ADDENDUM No. 1**2024 PARKING LOT AND ROADWAY IMPROVEMENTS****February 9, 2024**

This addendum forms a part of the Contract Documents and modifies the original Bidding Documents dated January 22, 2024. Acknowledge receipt of this addendum in the space provided on the bid form, failure to do so may subject the Bidder to disqualification.

2024 PARKING LOT AND ROADWAY IMPROVEMENTS

Eastern Iowa Airport (CID)
Cedar Rapids, IA
Pre-Bid Meeting
February 5, 2024

SHEET NO.
C.05

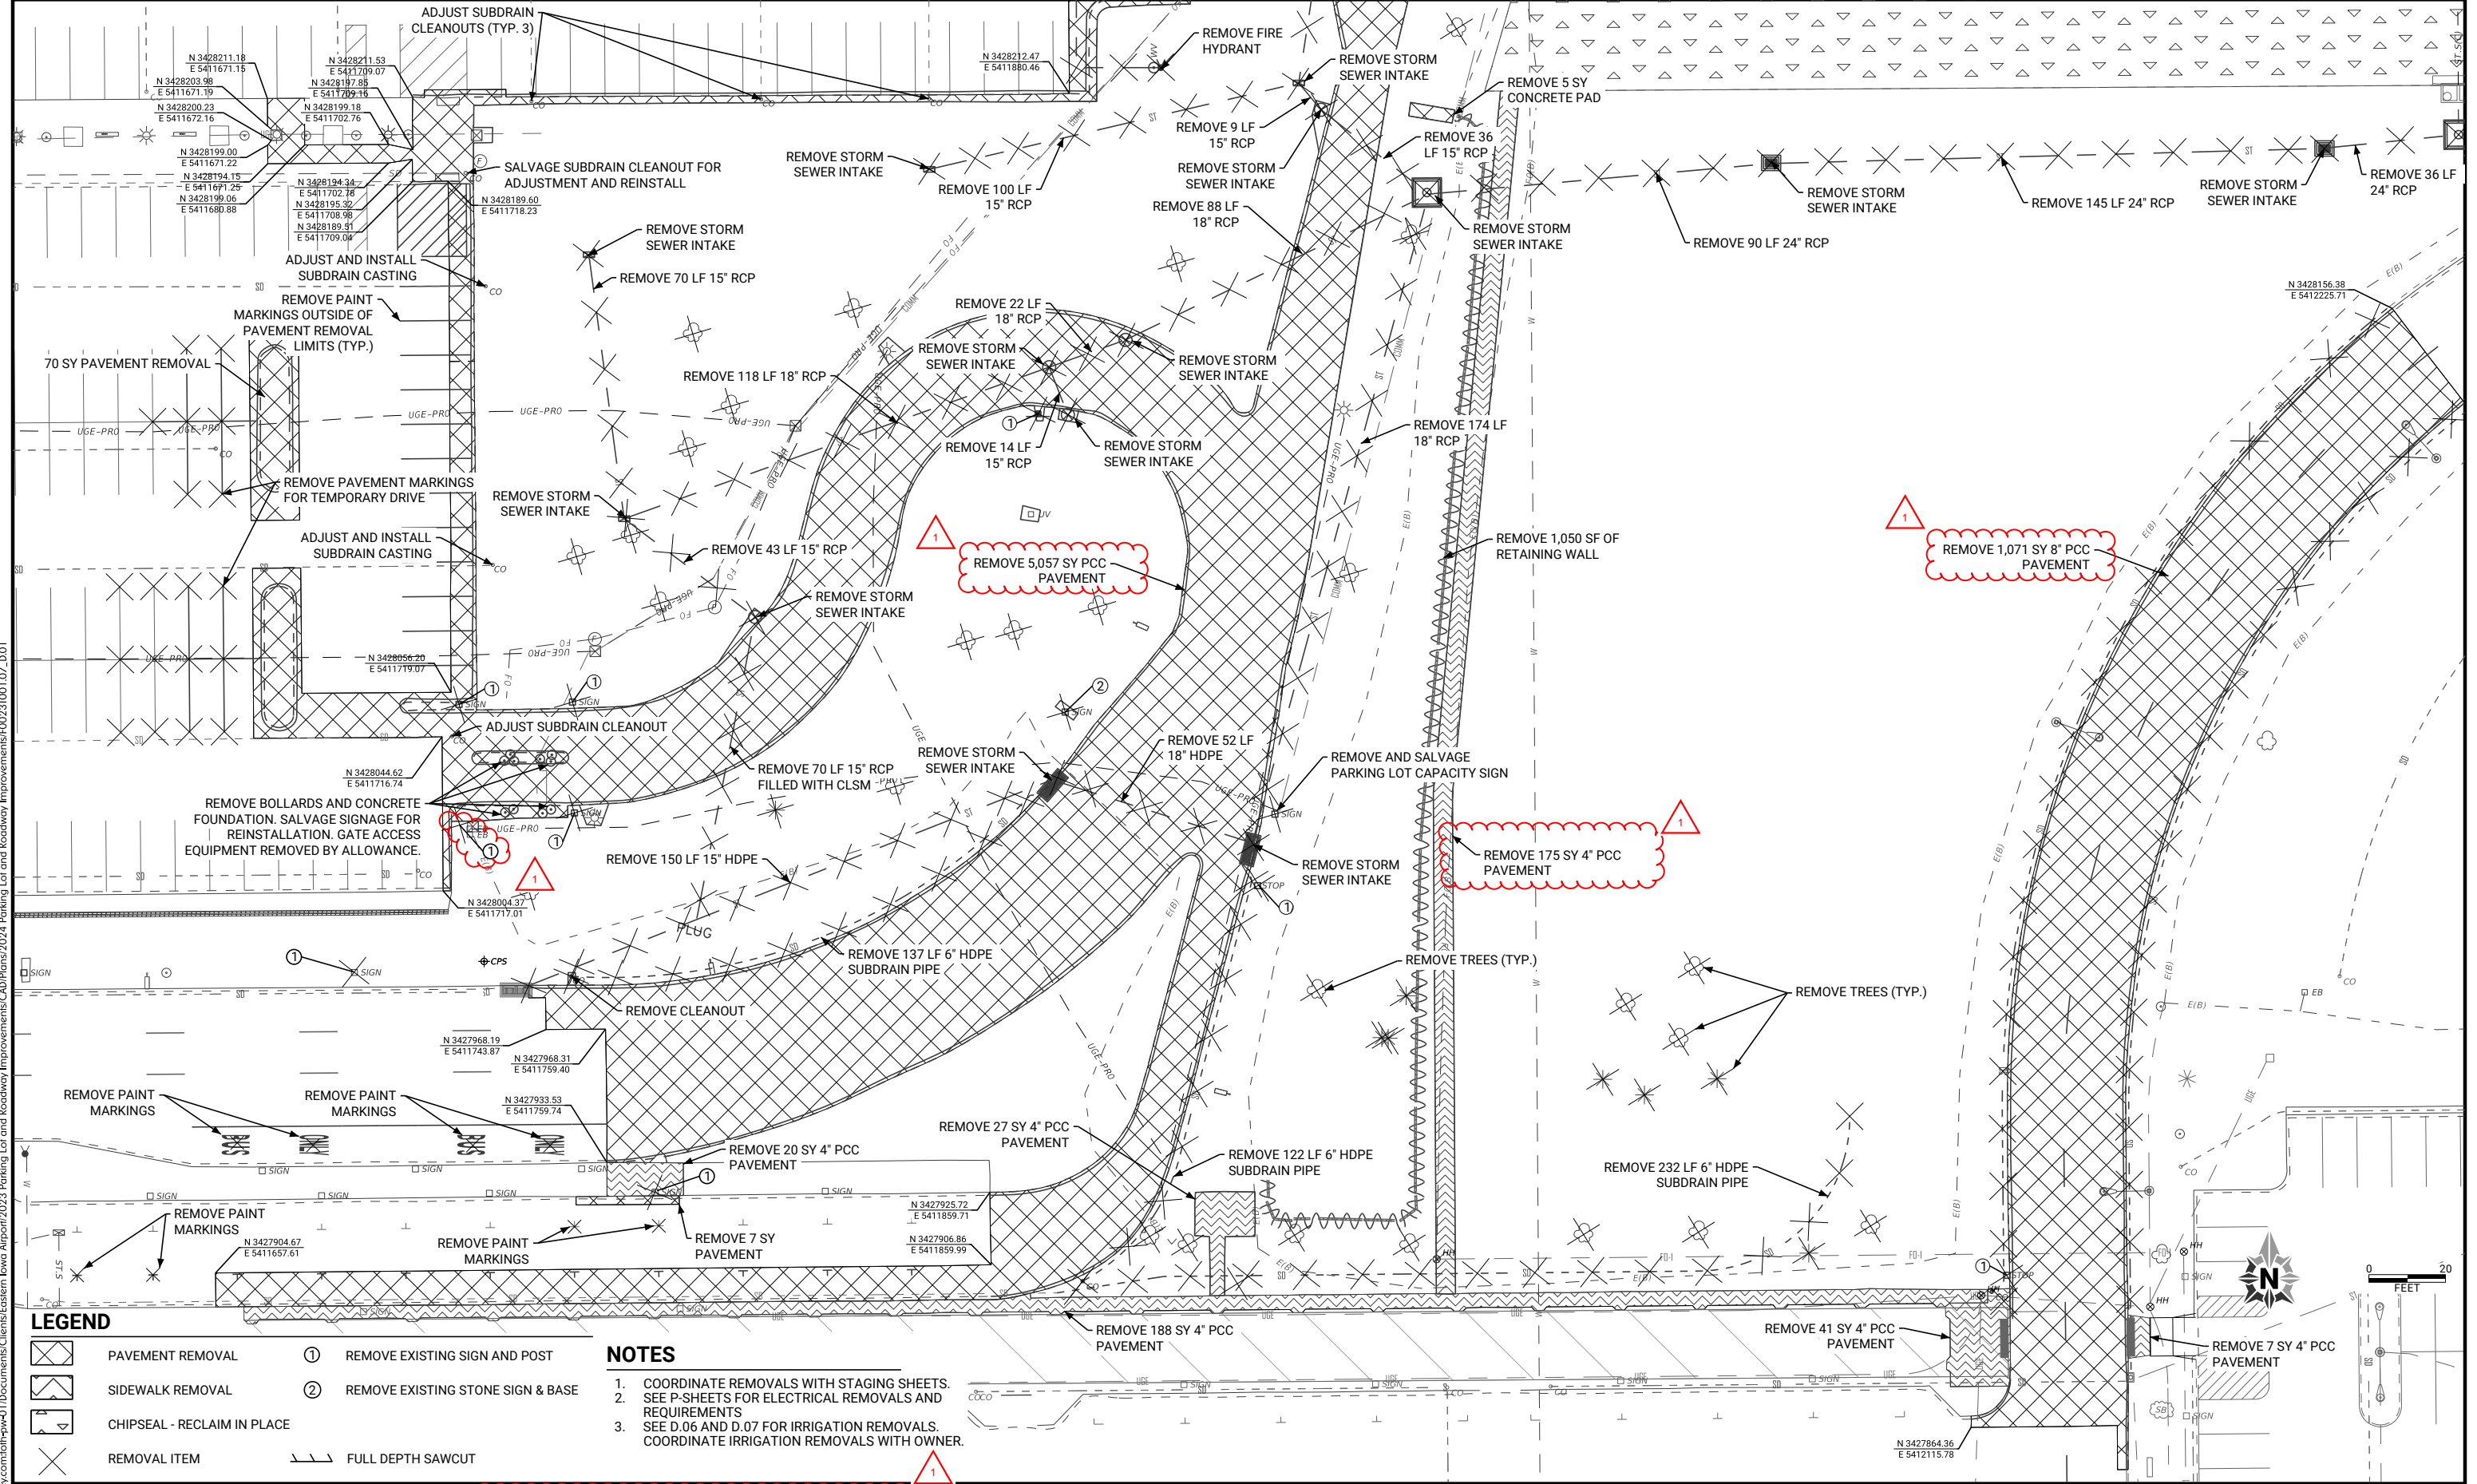
- c. **ADD** item 119, IRRIGATION REMOVAL
13. **Plan Sheet C.05:** (**ISSUED** with this addendum)
- a. **ADD** sheet in its entirety.
14. **Plan Sheet D.01:** (Revised and **REISSUED** with this addendum)

SHEET NO.
D.01

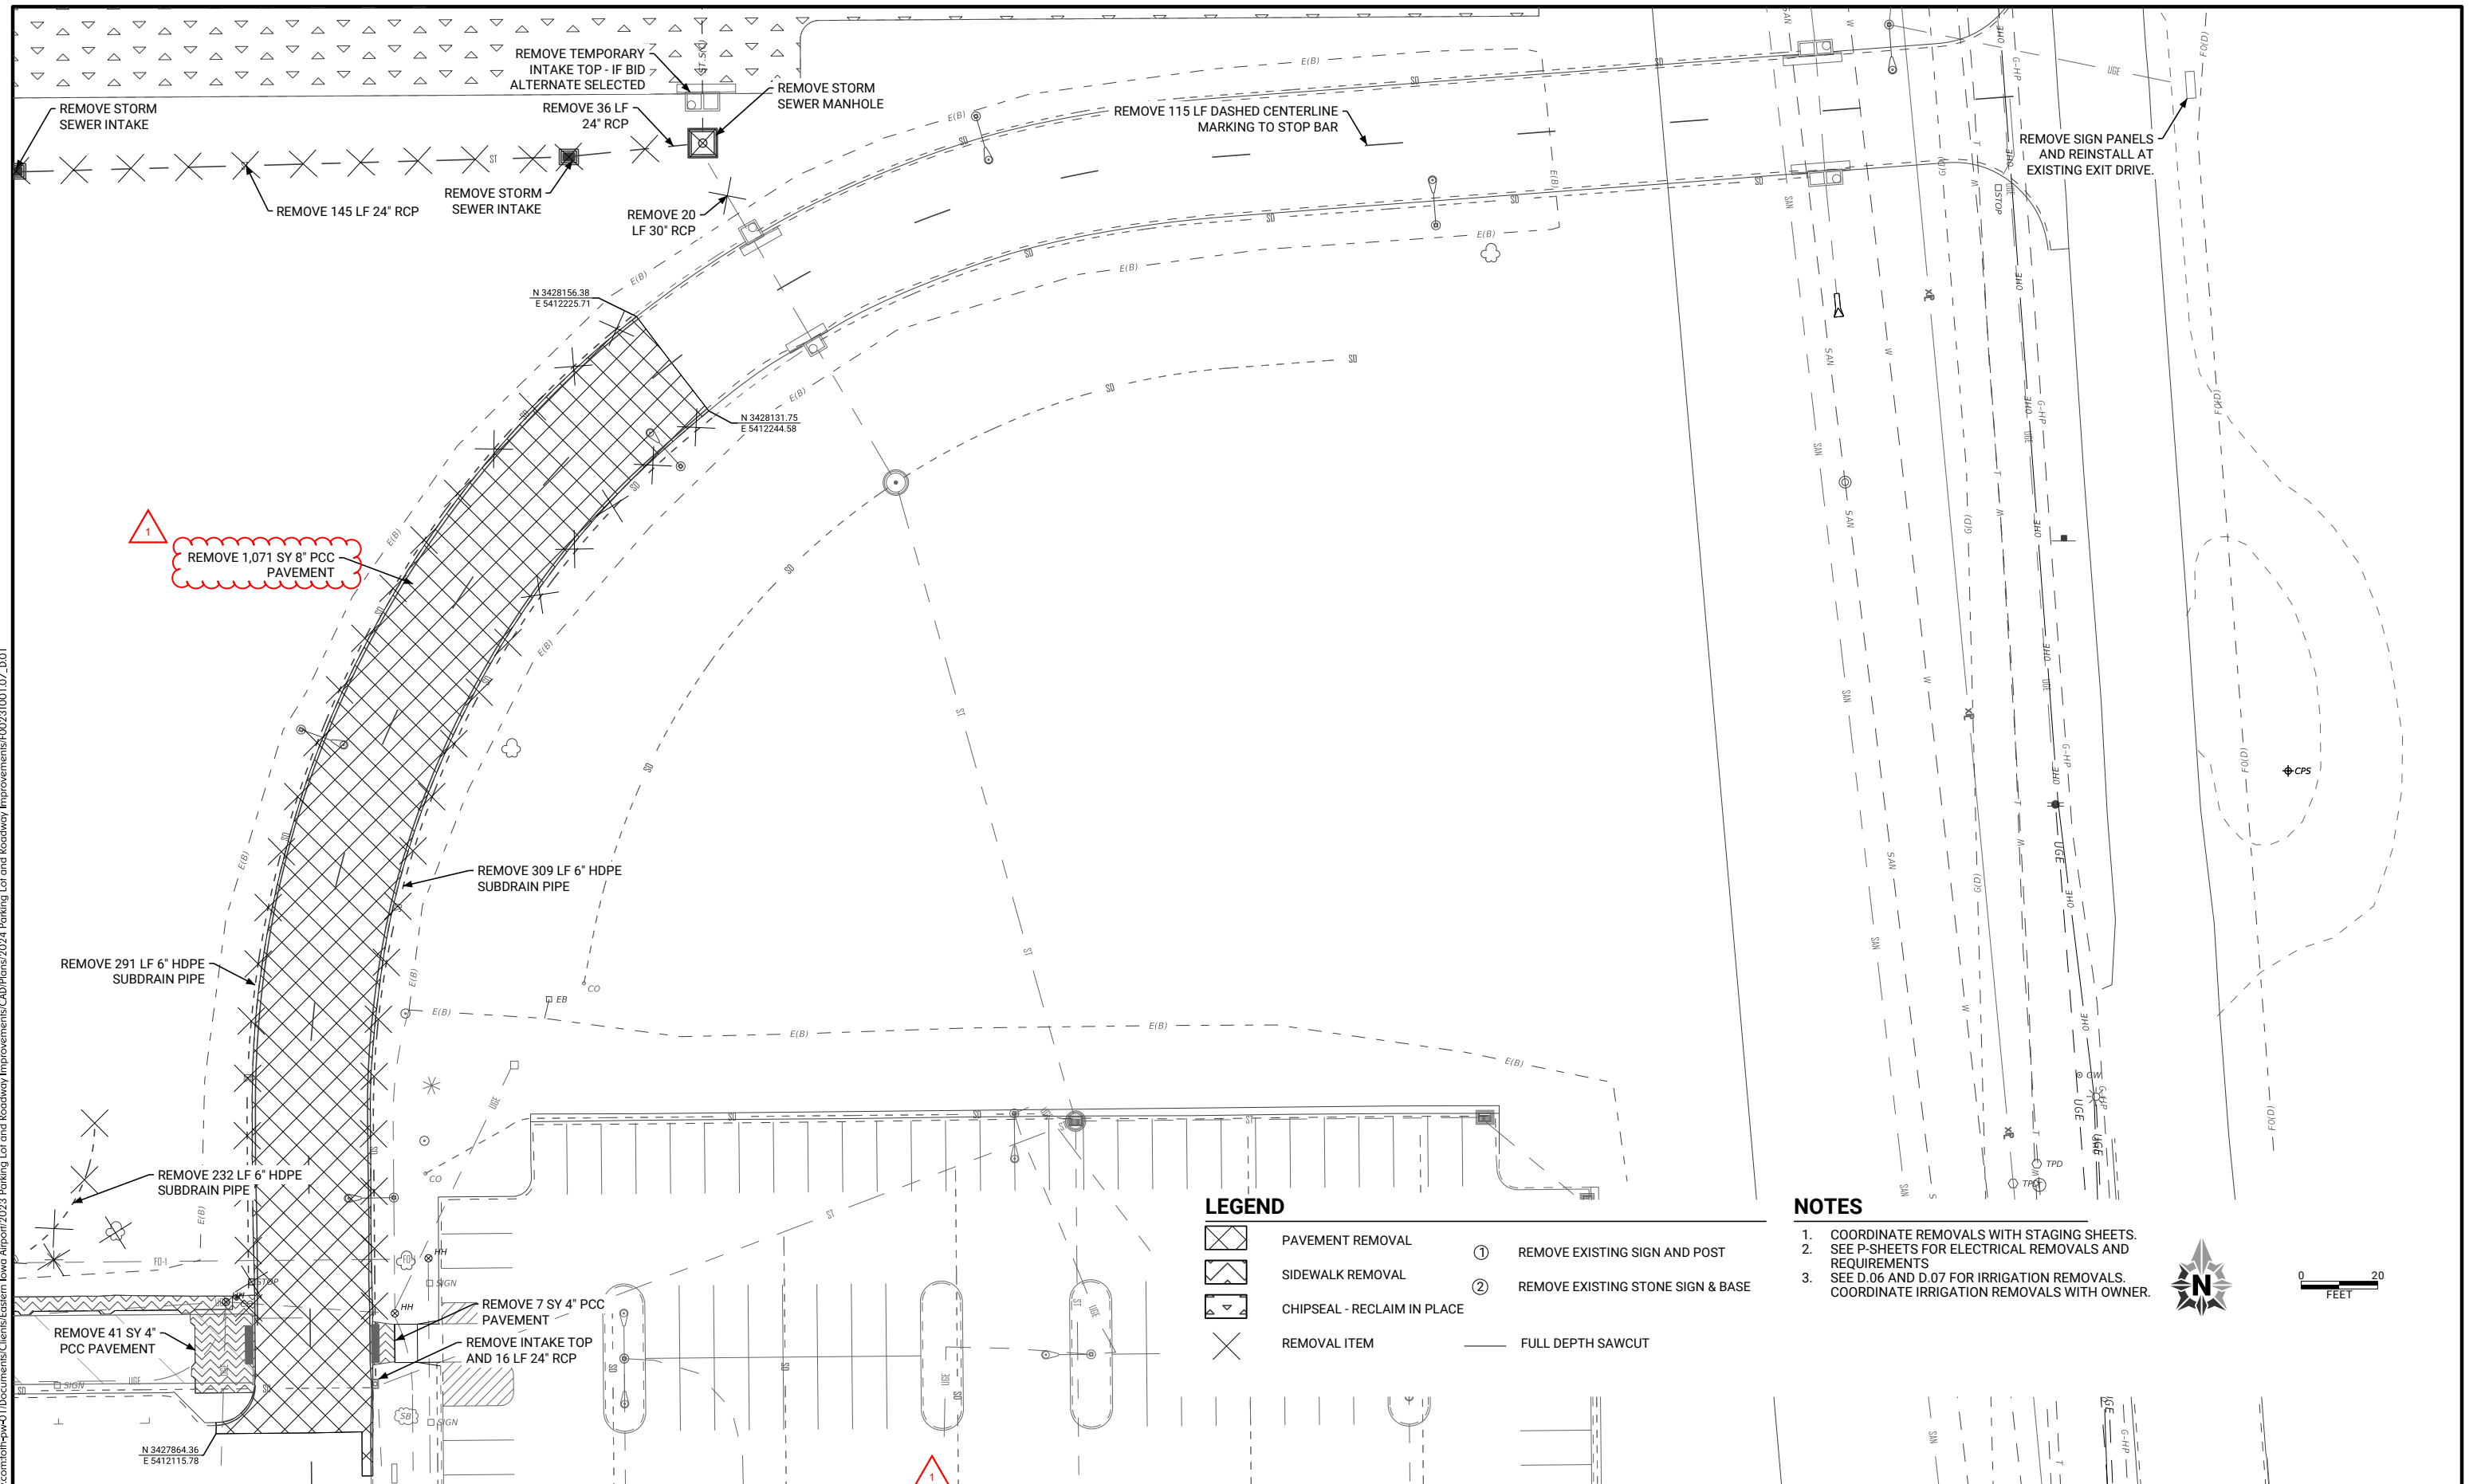
- a. **REVISE** removal note from 5,021 to 5,057.
 - b. **REVISE** removal note from 950 to 1,071.
 - c. **ADD** removal note for 175 SY of 4” PCC Pavement

- d. **ADD** removal callout for existing sign and post.
15. **Plan Sheet D.02:** (Revised and **REISSUED** with this addendum)
- a. **REVISE** removal note from 950 to 1,071.

01 GRAVITY LINES ALL SEWER (EARTH EXCAVATION)
SCALE: NONE

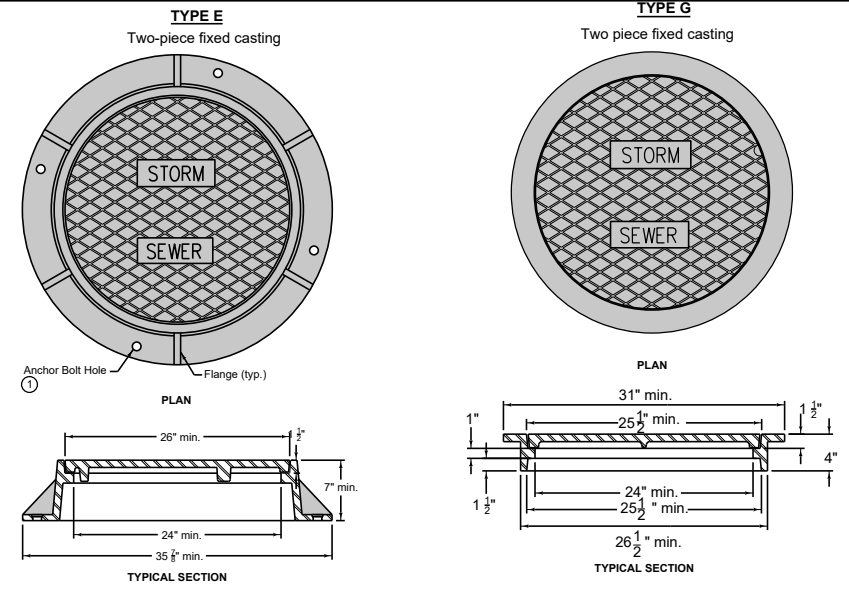
- b. Q: Is there a detail available for the 10" roof drain installation? Desired depth/backfill? And would an alternate of 8" SDR26 be considered? 10" SDR pipe and fittings can have a long lead time and hard to source.

- a. **REVISE** Detail 01 to reference note 4 and **ADD** note 4 indicating trench width for rigid and flexible pipe.
20. **Plan Sheet P.21:** (**Revised** with this addendum)

A: See detail 01 on sheet M.16 for gravity sewer earth excavation installation and backfill requirements. 12" SDR26 would be considered as an alternate to the 10". 8" SDR26 will not be considered as an alternate.

01 MH-1, MH-2 ELECTRICAL MANHOLE DETAILS
SCALE: NONE

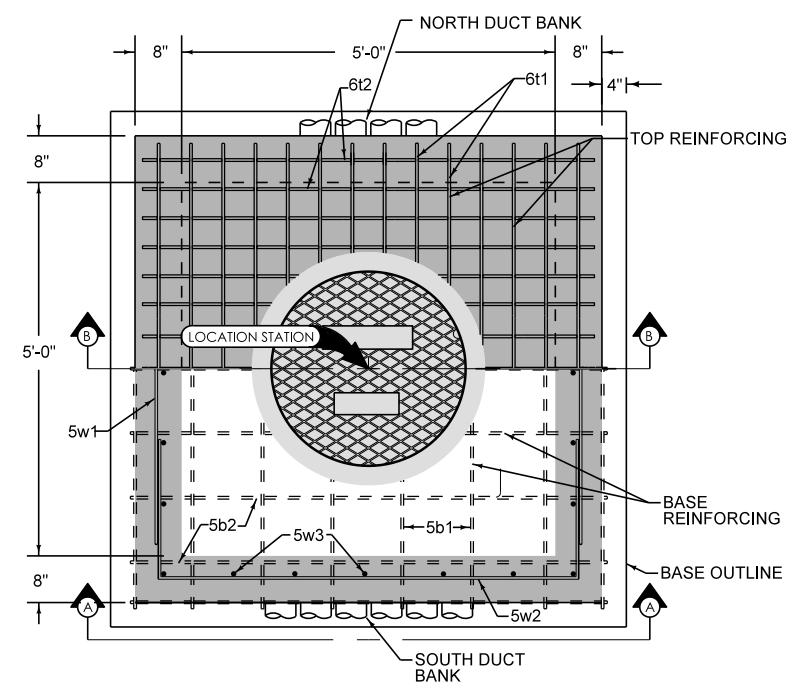
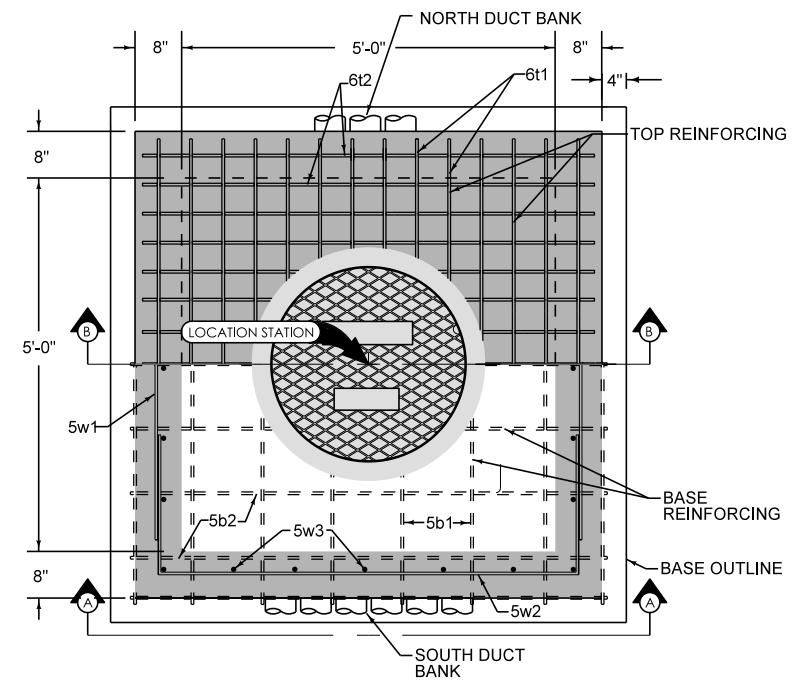
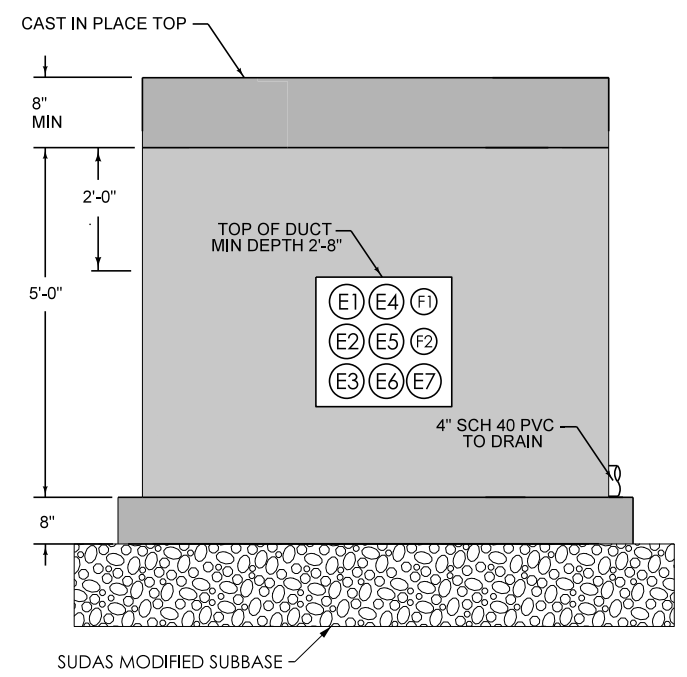
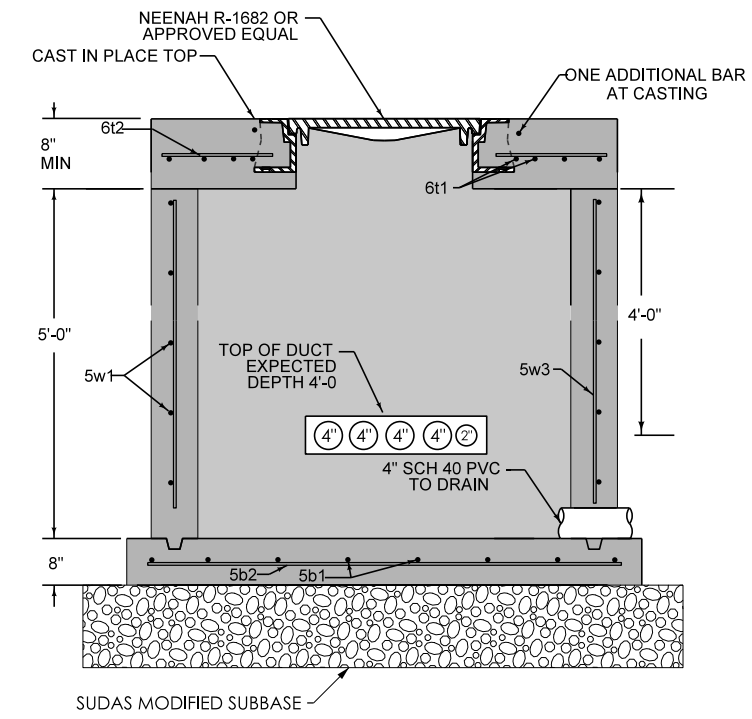
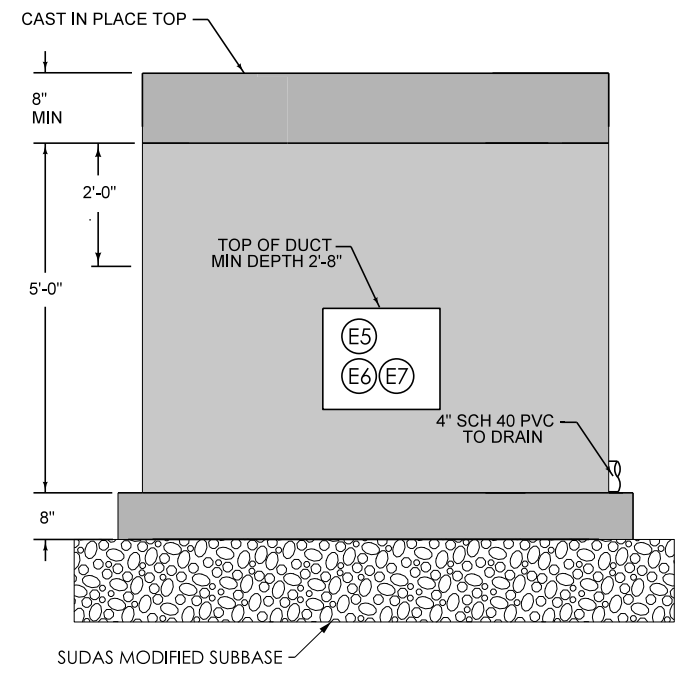
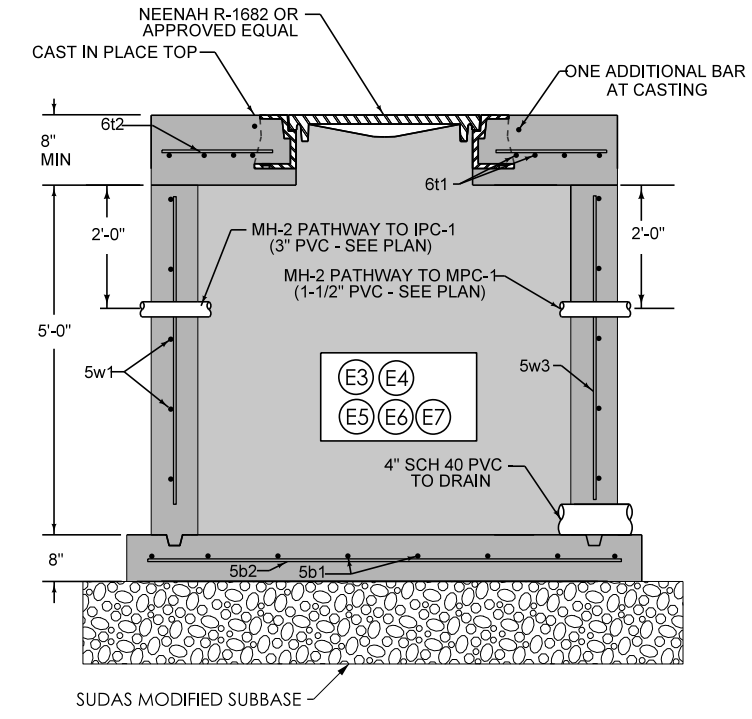
- a. **REVISE** HH-1 to MH-2 at intersection of concrete ductbank and conduit run to IPC-1.
21. **Plan Sheet P.61:** (**ISSUED** with this addendum)
 - a. **ADD** sheet in its entirety.
